SIL REPORT

**REPORT NO.
1189837.01.22**

**BUPC MEG Plant HAZOP & SIL Report –
N2 and Air Compressor
Detailed Design**

Client Report No: BUPC-17811-OO-0703

DRAWING TITLE: 17811-03 P&ID FOR INSTRUMENT AIR COMPRESSOR

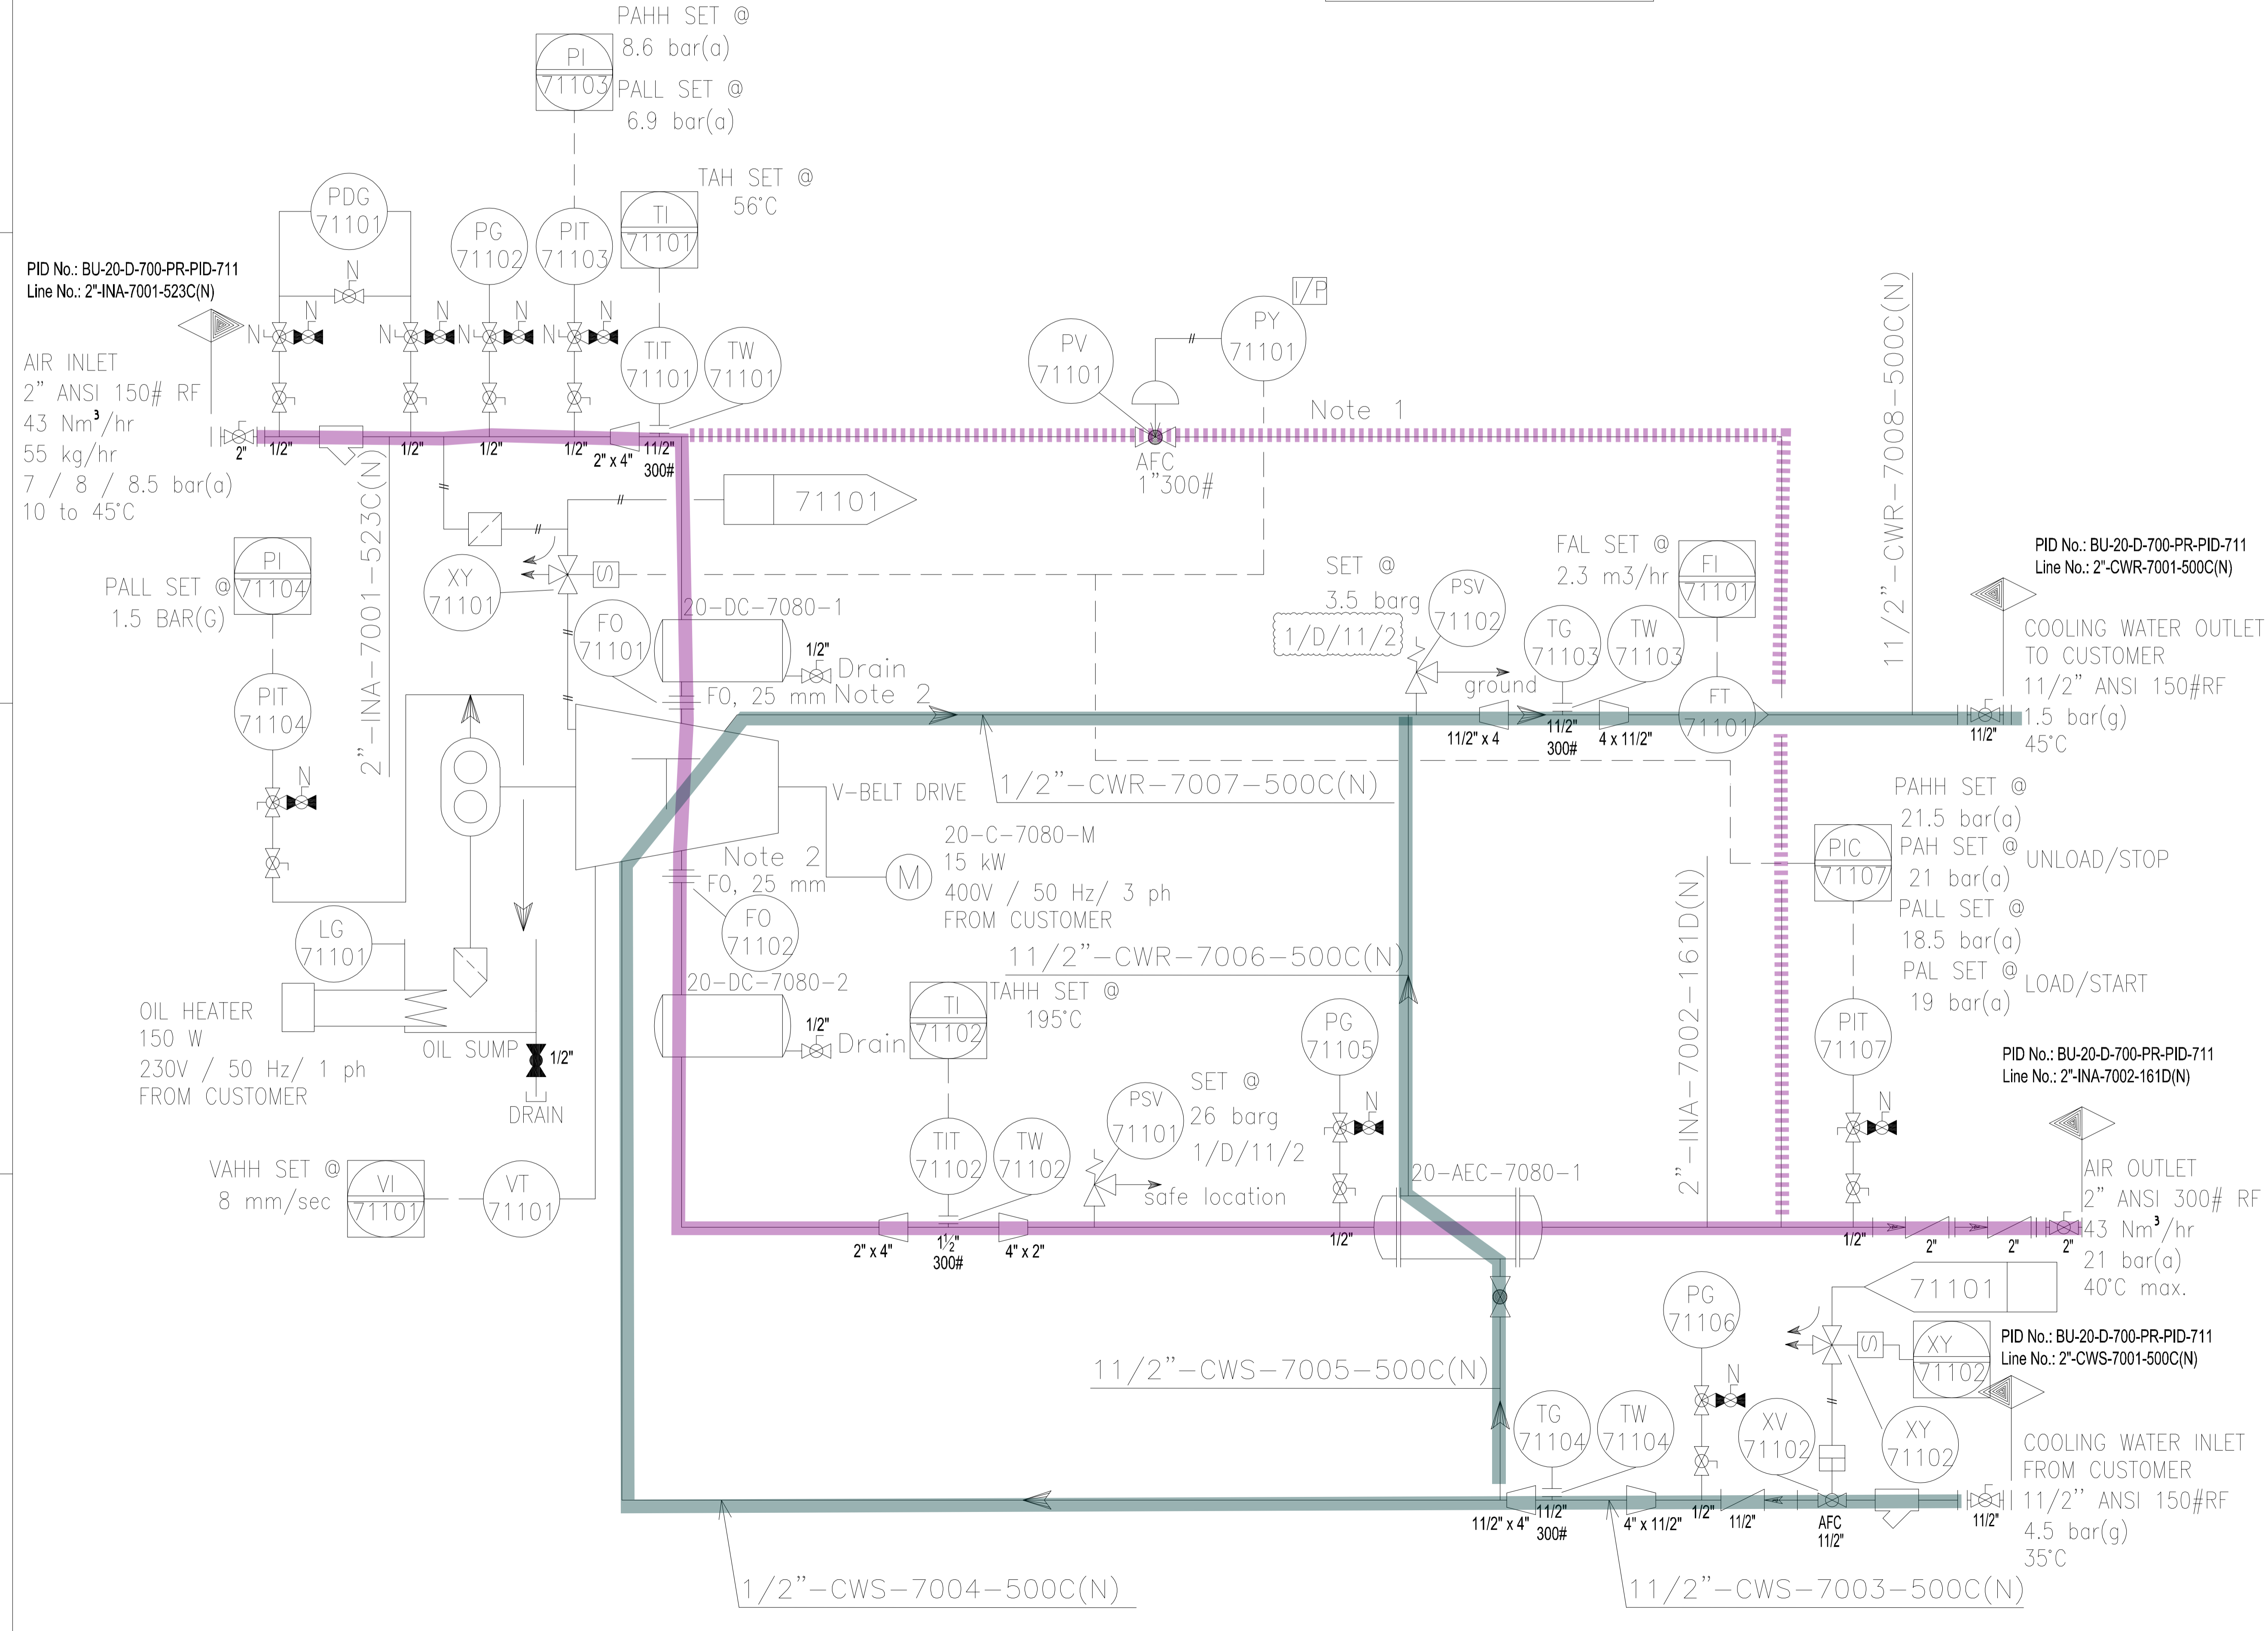
Node 3: Instrument Air

Node 4: Cooling Water AIR (IA) Compressor

03.1.1.1	Flow	No / Not	No/Less Flow	No Air supply from Plant	1. No Supply to the compressor leading to underpressure at the suction side of the compressor. Worst case is if recycle line is closed. No vacuum is expected, however the discharge pressure will decrease. Increase of temperature of the first stage exceeding the design temperature of the Compressor. Less supply to the end users. Vibrations of the axis of the compressor is possible. No loss of containment. No hazardous consequence. Asset damage (L) < 5000 US\$.	L	1. PIT-71103-PALL to Trip 20-C-7080 (UCP ESD) 1. PIT-71107-PALL to Trip 20-C-7080 (UCP ESD) 3. TIT-71102-TAHH to trip 20-C-7080 (UCP ESD)	1	3	SIL 0	1. PIT-71103-PALL to Trip 20-C-7080 (UCP ESD) 1. PIT-71107-PALL to Trip 20-C-7080 (UCP ESD) 3. TIT-71102-TAHH to trip 20-C-7080 (UCP ESD)	3	No action

03.2.1.1	Flow	More	More/High Flow	More flow over the recycle line by 'Fail Opened AFC PV-71101 or control failure to opened valve in case AFC should be NOT fully opened.	1. Decreased pressure and temperature in the second stage of the compressor. Less supply to the plant/ end user. No hazardous consequence; No asset consequence.		1. PIT-71107-PALL to trip 20-C-7080 (UCP ESD)
